16/01-04A 20500 Martinsburg Rd  
MP Site 16/1 Trundle Farm

SUBJECT: Historic Area Work Permit # 320682

**HISTORIC PRESERVATION COMMISSION STAFF REPORT**

**PROPOSAL:** Installation of pool and landscaping features

SITE PLAN

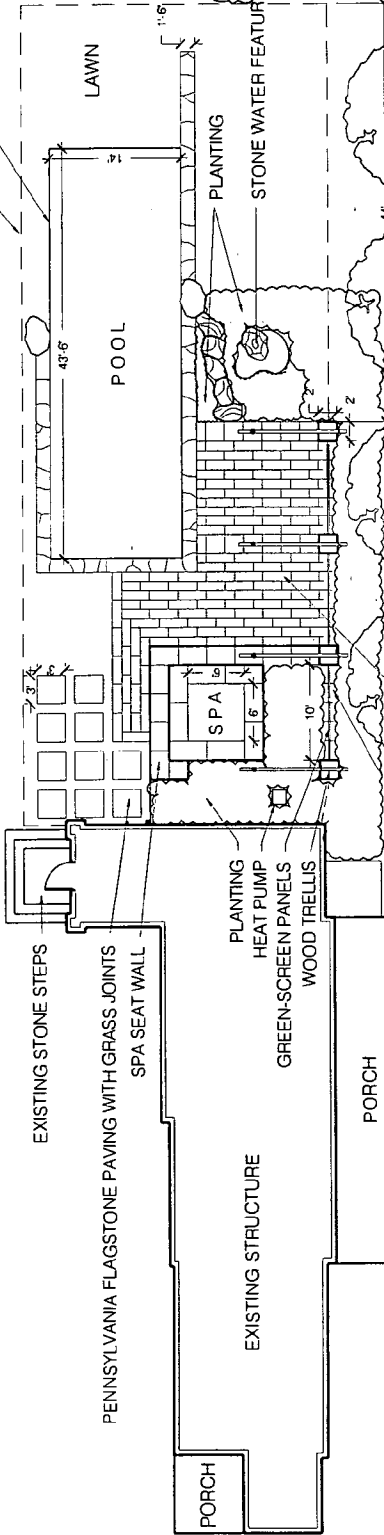
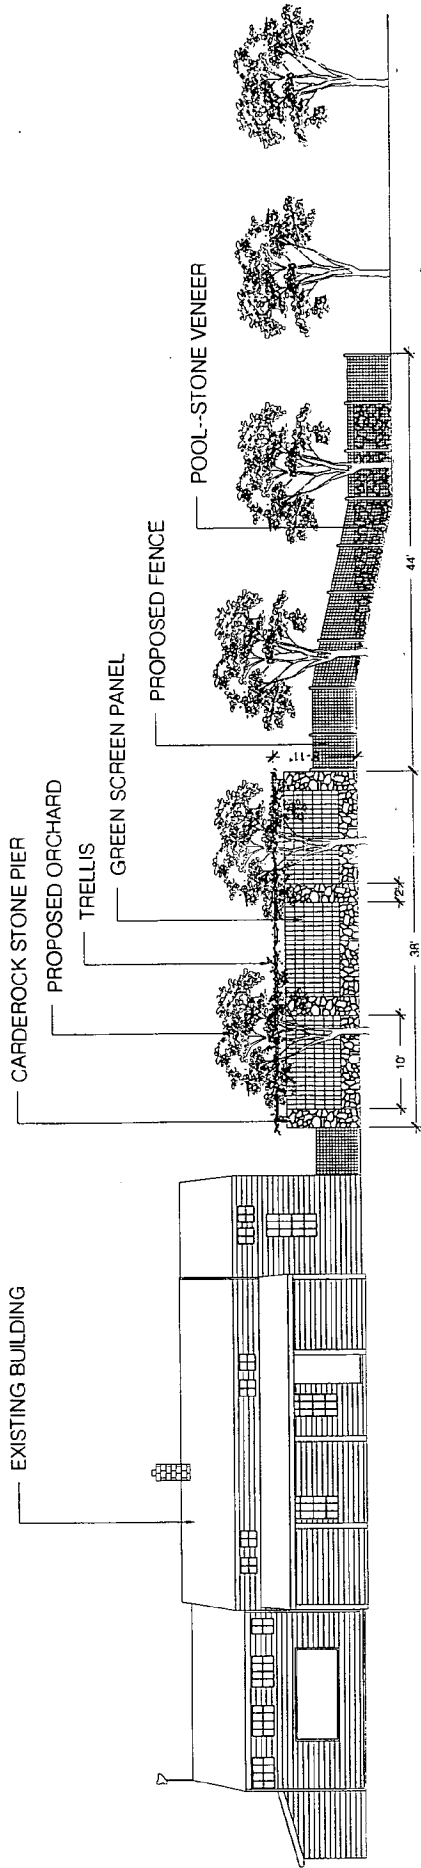
The applicant plans to plant a new orchard of trees northeast of the house between the pool and the road (see Detailed Site Plan in Circle 8 ).

The applicant has strategically sited this pool where it will have the least impact on one of the most unique and important features of this resource—the vista. The virtually untouched rural setting of this house with its unique sandstone outbuilding make it truly a find in Montgomery County and staff is pleased to see an owner who appreciates the importance of the pristine setting. Rather than place the pool smack in the middle of the back yard and obstruct the vista and the relationship between the house and outbuilding, this proposal has the pool tucked away to the side of the house where it will have a minimal impact on the historic resource and the beautiful setting.

north end of pool site (maximum 5 trees to be removed)

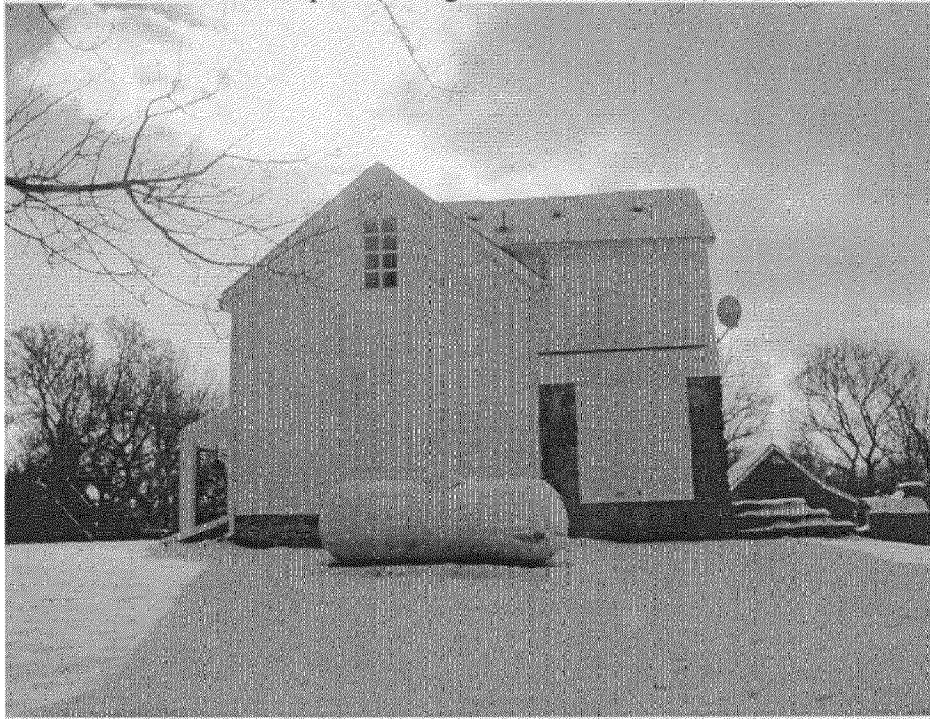
To place the pool in this location the applicant must remove no more than five trees from the far north side of the proposed pool site. According to the landscape architect (see Circle 10 ):

The pool and the additions to the surrounding area are also designed to be unobtrusive and to create a naturalistic setting with lots of grass, a small amount of decking, and the use of compatible materials including flagstone, carderock stone, wood trellis, simple and open fencing, and green screen. The trees that need to be removed are not large and not specimen trees. Staff recommends approval of the proposal.
